Access Compliance Report

Public Rights-of-Way

(Curb Ramps)

Intersection ID: N/A	Main Street: CALABASSAS LN	Cross Street: NORTHEAT PWY	Location: SE
ADA ID: 5858756AC7ED	Ramp Type: PerpDiag	Initial Pass/Fail: Fail	Overall Compliance: No
Codes/Mitigation Info/Possible Solution		Field Measurements/Component Compliance	
Severity Score: 22.5

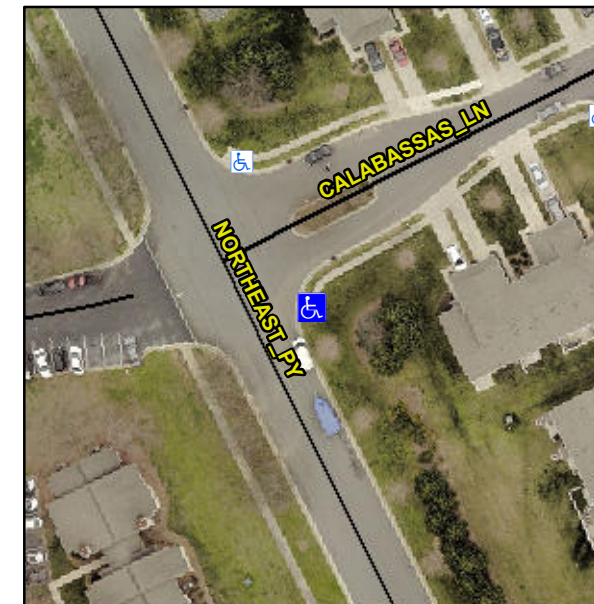
R304.5.1, R304.2.2, R304.5.3

Compliance	Description	Data	Compliance	Description	Data
N/A	Ramp Length (in)	48.0	No	Ramp Slope (%)	9.3
No	Ramp Width (in)	41.0	No	Ramp XSlope (%)	4.4
N/A	Flare Type LT	N/A	N/A	Flare Type RT	N/A
N/A	Flare Slope LT (%)	N/A	N/A	Flare Slope RT (%)	N/A
N/A	Flare Traversable LT?	No	N/A	Flare Traversable RT?	No
N/A	Landing Length (in)	N/A	N/A	DWS Provided?	N/A
N/A	Landing Width (in)	N/A	N/A	DWS Contrast?	N/A
N/A	Landing Slope (%)	N/A	N/A	DWS Length (in)	N/A
N/A	Landing X Slope (%)	N/A	N/A	DWS Full Width?	N/A
N/A	Landing Curb? (Y/N)	N/A	N/A	DWS Offset (in)	N/A
N/A	Shared Landing?	N/A			
N/A	Gutter Ponding?	N/A	N/A	Gutter Slope (%)	N/A
N/A	Gutter Lip Ht (in)	N/A	N/A	Gutter X Slope (%)	N/A
N/A	Painted X Walk1?	No	N/A	Painted X Walk2?	No
	X Walk 1 Direction	To N		X Walk 2 Direction	To W
N/A	X Walk 1 Width (in)	N/A	N/A	X Walk 2 Width (in)	N/A
	X Walk 1 Slope (%)	1.6		X Walk 2 Slope (%)	0.7
	X Walk 1 X Slope (%)	3.4		X Walk 2 X Slope (%)	3.5

Remove & Replace Curb Ramp With Two New Directional Ramps or Equivalent.
